Urgent Field Safety Notice

Applicable to REPLY, ESPRIT, KORA and FACIL¹ pacemakers
manufactured by Sorin Group Italia S.r.l.

Improved residual longevity displayed by the programmer

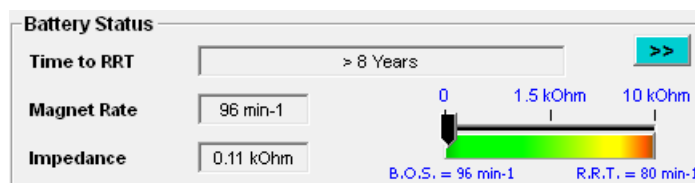
With the new programmer software version, the Time to RRT is displayed as follows:

- If the **typical estimated time to RRT** is **>3 years**, the “*typical time to RRT*” is displayed and the corresponding text field background is grey.

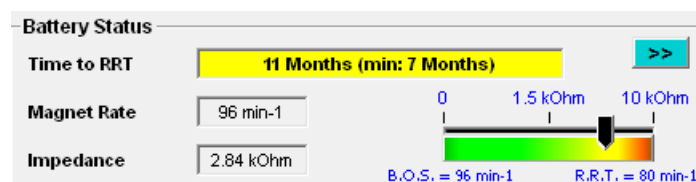
- If the **typical and minimal estimated time to RRT** are **between 3 months and 3 years**, the “*typical time to RRT in years and months (Minimal time to RRT)*” are displayed and:
 - the corresponding text field background is grey, if the **minimal estimated time to RRT** is **>12 months**;

- The corresponding text field background is yellow, if the **minimal estimated time to RRT** is **≤12 months**. A Warning will be displayed “*In the current conditions of use, the minimum residual longevity ≤ 12 months.*”

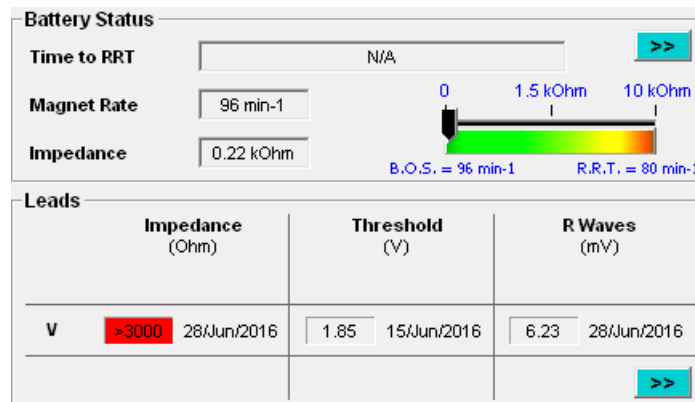
- If the **minimal estimated time to RRT** is **<3 months**, “< 3 months” is displayed and the corresponding text field background is orange. A Warning will be displayed: “*In the current conditions of use, the minimum residual longevity ≤ 3 months.*”

- If the **RRT has been reached**, “RRT has been reached” is displayed and the corresponding text field background is red.

- “NA” is displayed in the text field, and the corresponding text field background is grey:
 - If less than 5 minutes statistics are available (i.e. first interrogation at implant, device reset),
 - If lead impedance is abnormal (< 200 and $\geq 3000 \Omega$) in any of the programmed cavity.
